**SUBJECT:** COMANCHE PEAK NUCLEAR POWER PLANT, UNITS 3 AND 4  
DOCKET NUMBERS 52-034 AND 52-035  
SUPPLEMENTAL INFORMATION FOR RESPONSE TO REQUEST FOR ADDITIONAL  
INFORMATION NO. 4206

**RAI NO.: 4206 (CP RAI #135)**

**SRP SECTION: 12.03-12.04 - Radiation Protection Design Features**

**QUESTION NO.: 12.03-12.04-11**

Figure 11.2-201 Liquid Waste Management System Piping and Instrumentation Diagram (Sheet 10 of 10)

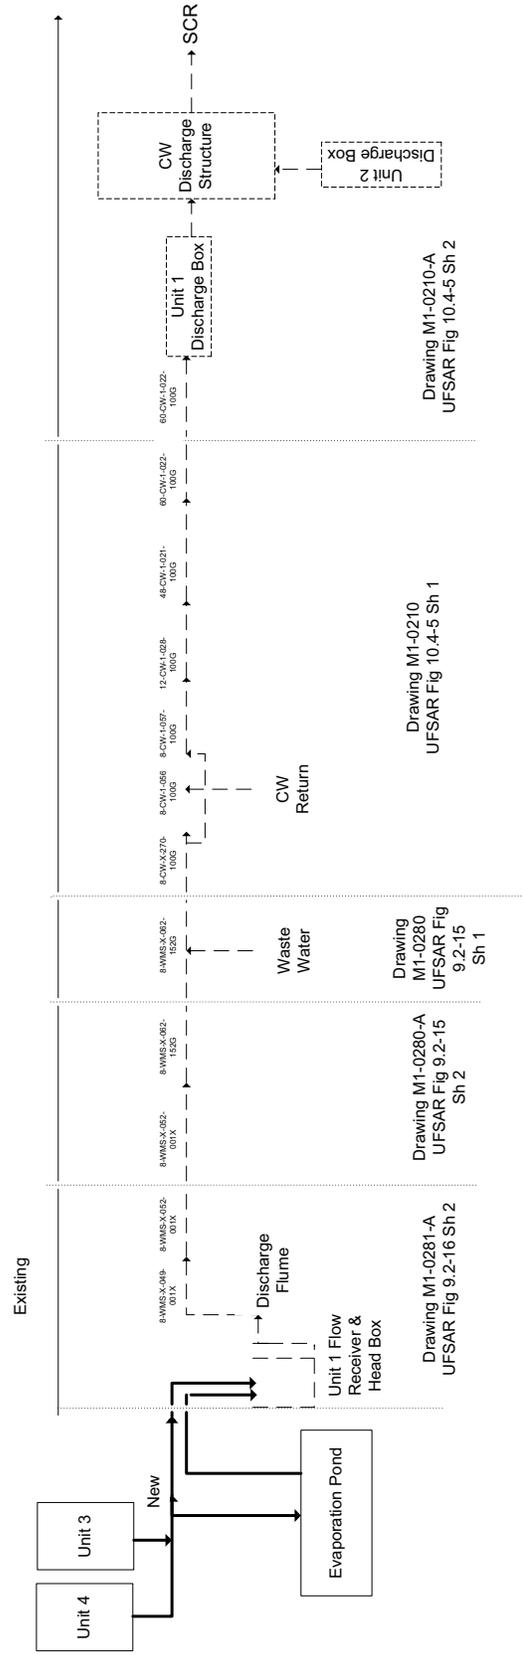
- The applicant was asked to describe the provisions for those portions cooling water systems, down stream of the Liquid Waste Processing System (LWPS) connection points. While the applicant noted that evaporation pond piping would use leakage detection and inspection ports, neither this response, nor the response to RAI No. 2747 (CP RAI # 29), Question 11.02-2, dated September 24, 2009, noted this provision in the COL FSAR changes. This response also does not address the piping down stream of where the discharge piping from the evaporation pond connects to the cooling water discharge piping. The "Liquid Radioactive Release Lessons Learned Task Force Final Report" describes industry-operating experience involving inadvertent releases from cooling water piping or components located down stream of LWPS connections.

1. The treated effluent from Units 3 and 4 and the radwaste evaporation pond are piped directly to the Unit 1 flow receiver and head box (see attached FSAR Figure 11.2-201 Sheet 10). The effluent from the Unit 1 flow receiver and head box flows to the Unit 1 discharge flume, then through existing Unit 1 piping to the Unit 1 circulating water system, and then to Squaw Creek Reservoir (SCR). This was addressed in FSAR Subsection 11.2.2 by response to RAI No. 2747 (CP RAI #29) on September 24, 2009 (ML092720676) and is included for convenience below:

The treated liquid effluents released from the CPNPP Units 3 and 4 and the evaporation pond are piped directly into the Unit 1 Waste Management System (WMS) flow receiver and head box, which includes the discharge flume. The effluents enter from the top of the receiver and head box and are above the liquid level in the box so that they flow freely into the box, from where the content flows to the Unit 1 WMS discharge flume, and by gravity to the Unit 1 Circulating Water System (CWS), via an existing Unit 1 pipeline connecting the WMS to the CWS. At this pipeline intersection, the Unit 3 and 4 treated effluent and the Unit 3 and 4 evaporation pond effluents are commingled with various Unit 1 and 2 waste effluent streams. This Unit 1 circulating water flow path then goes to the Unit 1 condenser water box outlet, where it joins the Unit 2 condenser water box outlet flow. The joined flows from the Unit 1 and 2 condenser water boxes are then sent to the SCR via the Unit 1 and 2 discharge tunnel and outfall structure from all four units (see Figure 11.2-201 Sheet 10 for a visual representation of the above described flow path.)
